Access Compliance Report

Public Rights-of-Way

(Curb Ramps)

Intersection ID: 28660	Main Street: HOFFMAN_CT	Cross Street: KEELS_CT	Location: NE
ADA ID: 353619DED258	Ramp Type: BlendTrans2	Initial Pass/Fail: Fail	Overall Compliance: No
		Severity Score: 25

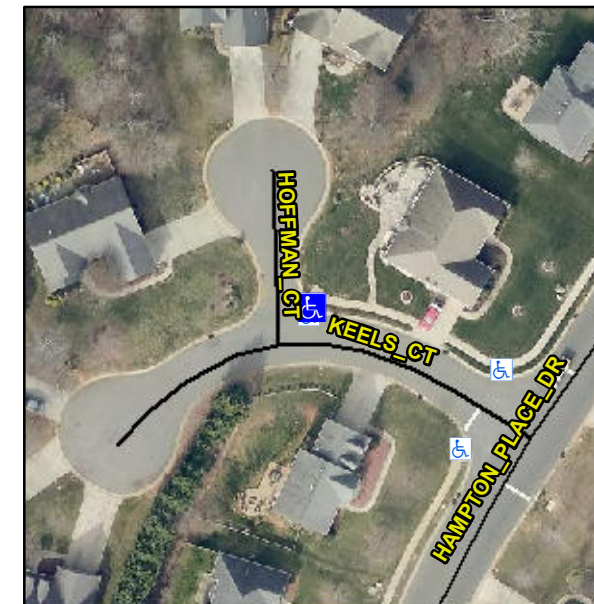
R304.5.3

Compliance	Description	Data	Compliance	Description	Data
N/A	Ramp Length (in)	97.5	Yes	BlendTrans Slope (%)	2.5
Yes	Ramp Width (in)	110.5	No	BlendTrans XSlope (%)	9.0
N/A	Flare Type LT	N/A	N/A	Flare Type RT	N/A
N/A	Flare Slope LT (%)	N/A	N/A	Flare Slope RT (%)	N/A
N/A	Flare Traversable LT?	N/A	N/A	Flare Traversable RT?	N/A
N/A	Landing Length (in)	N/A	N/A	DWS Provided?	N/A
N/A	Landing Width (in)	N/A	N/A	DWS Contrast?	N/A
N/A	Landing Slope (%)	N/A	N/A	DWS Length (in)	N/A
N/A	Landing X Slope (%)	N/A	N/A	DWS Full Width?	N/A
N/A	Landing Curb? (Y/N)	N/A	N/A	DWS Offset (in)	N/A
N/A	Shared Landing?	N/A			
N/A	Gutter Ponding?	N/A	N/A	Gutter Slope (%)	N/A
N/A	Gutter Lip Ht (in)	N/A	N/A	Gutter X Slope (%)	N/A
N/A	Painted X Walk1?	No	N/A	Painted X Walk2?	N/A
	X Walk 1 Direction	To S		X Walk 2 Direction	N/A
	X Walk 1 Width (in)	N/A		X Walk 2 Width (in)	N/A
	X Walk 1 Slope (%)	4.8		X Walk 2 Slope (%)	N/A
	X Walk 1 X Slope (%)	4.7		X Walk 2 X Slope (%)	N/A

Remove & Replace Curb Ramp With Two New Directional Ramps or Equivalent.
